CERTIFICATE OF APPROPRIATENESS

Applicant: Justin Patterson, agent, Jeff Stone, owner.

Property: 717 E. 5th ½ Street, Lot 2, Block 1, Freeland Subdivision. The property is a 7,180 SF vacant corner lot.

Proposal: New Construction – The applicant is proposing to construct a two-story single-family residence and garage. The proposal is as follows:

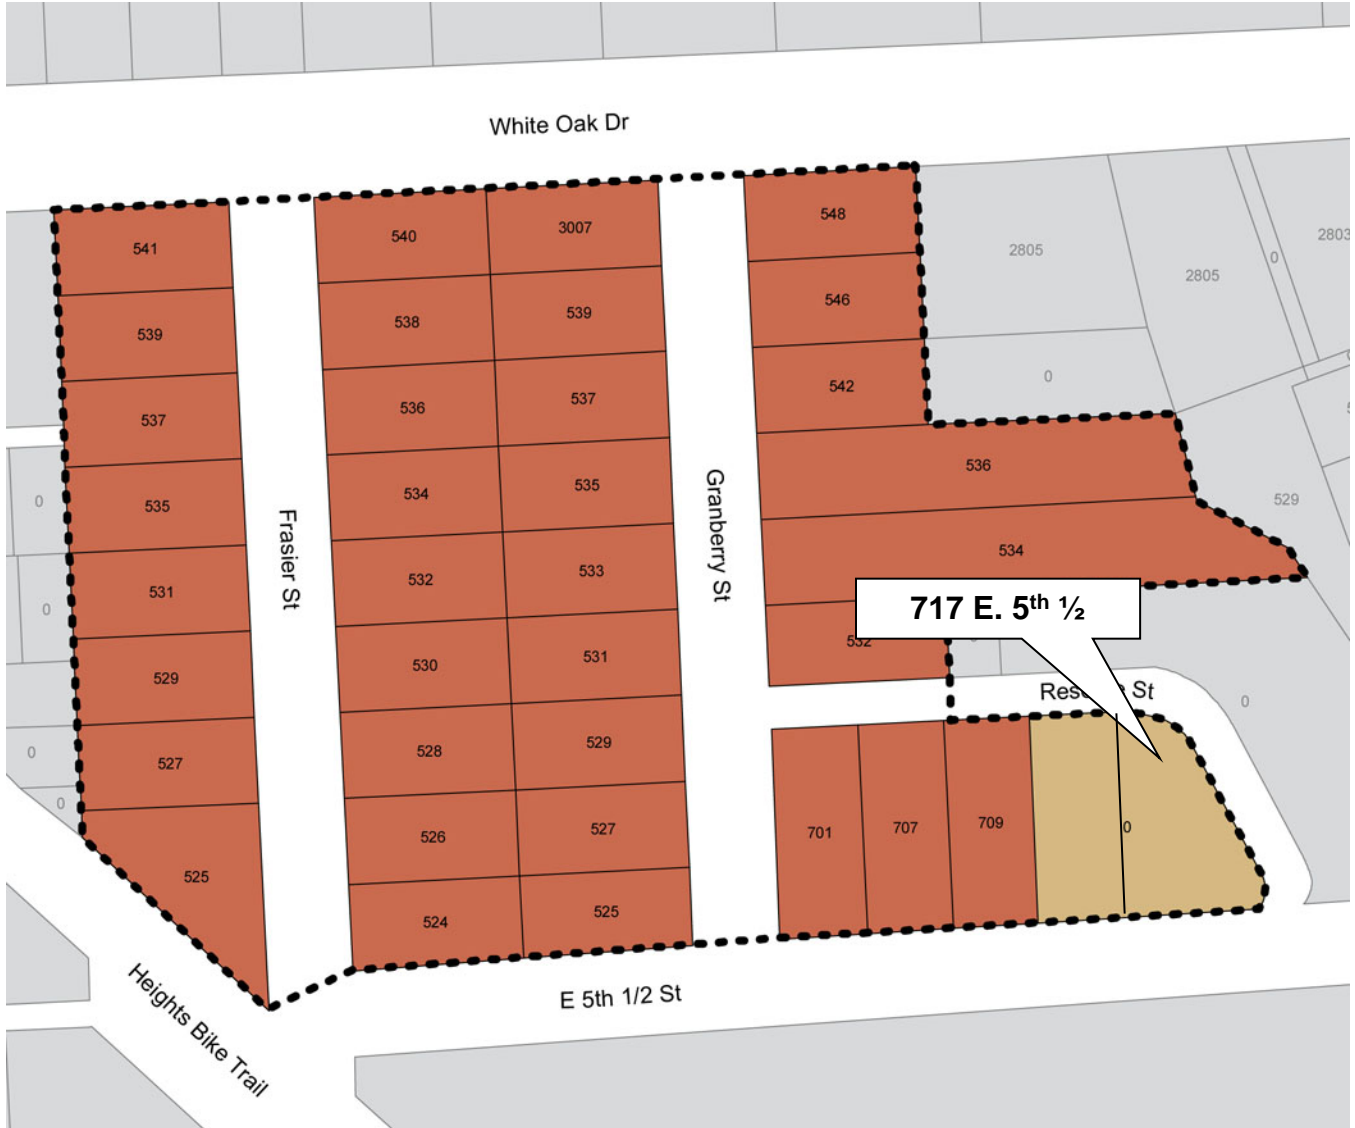
- (2) The exterior features of the new construction must be compatible with the exterior features of existing contributing structures in the context area; *Exterior features of proposed design are compatible with contributing structures in the context area as the front elevation attempts to be a one-story structure with a 25'-8" ridge height.*

- (3) The scale and proportions of the new construction, including the relationship of the width and roofline, overall height, eave height, foundation height, porch height, roof shape, and roof pitch, and other dimensions to each other, must be compatible with the typical scale and proportions of existing contributing structures in the context area unless special circumstances, such as an atypical use, location, or lot size, warrant an atypical scale and proportions; *The scale, proportions, and some other dimensions are not at all compatible with the typical scale of existing contributing structures in the context area; the lot for this project is at the end of the district with an unusual street configuration around it, allowing for the large mass to be viewed from three sides.*

- (a) Design guidelines for an individual historic district may provide that a new construction with two stories may be constructed in a context area with only one-story contributing structures as long as the first story of the new construction has proportions compatible with the contributing structures in the context area, and the second story has similar proportions to the first story; *Freeland does not have design guidelines, and this design has a second-story that begins much too close to the front. The proportions do not match the contributing one-story structures which have second-story additions. Thus, the proportions from this design are not compatible.*

- (b) A new construction shall not be constructed with more than one story in a historic district that is comprised entirely of one-story contributing structures, except as provided for in design guidelines for an individual historic district. *There are contributing homes in the historic district that have second story rear additions and two-story garages (two examples shown in the report, 527 Granberry and 527 Frasier). Freeland does not have design guidelines, however the massing of this home is solely a two-story structure.*
